Government of India
Ministry of Railways
Research, Designs & Standards Organisation
Manak Nagar, Lucknow - 226 011

Modification Sheet No. RDSO/WAM4/166

- 1. Title :** Modified support plate assembly for main pole and commutating pole of TAO 659 Traction Motor.
- 2. Application :** All electric locomotives viz. WAM4, WAP1, WCAM1 & WAG5 fitted with TAO 659 Traction Motor.

REF:	SCALE:- 1:2	APPD.	FOR DG
SUPPORT PLATE FOR MAIN POLE OF TAO-659 TRACTION MOTOR.			
R.D.S.O.ELEC.DTE.			SKEL - 4084

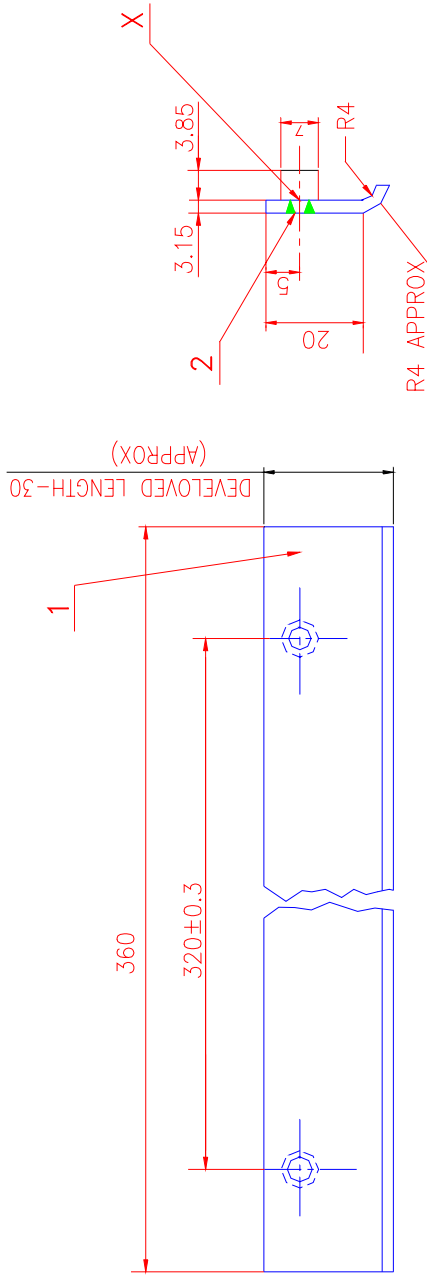
- 3. Object :**
 - 3.1 :** Railways have reported No. of cases of main pole, field coil and compole field coil getting earthed on account of working out of dowel pin in support plate. The dowel pin generally pierce into the insulation due to poor brazing of dowel pin with the support plate and thus leading to damage of coil insulation.

- 3.2 :** It has been observed that the strength of brazed joint between the pin and support plate is weak and leading to working out of the pin.
 - 3.3 :** This modification intends to modify the design of dowel pin as well as improved brazing area to prevent failure of this nature.

- 4. Details of Modification :**
 - 4.1 :** The holes in the support plate should be counter sunk as shown as shown in the drawing.
 - 4.2 :** The drilling of the holes should be done on suitable jig so that pins fitted easily and quickly into the holes on the 'L' plates.

- 4.3 :** The double pin of modified profiles as shown in RDSO's drawing No. SKEL - 4083 & SKEL - 4084 may be brazed with the support plates.
 - 4.4 :** Silver brazing should be done and the area should be properly dressed up.

- 4.5 :** Holes for fixing the support plate in compole piece assembly and main pole piece assembly should be suitably drilled to accommodate the revised profile of dowel pin.
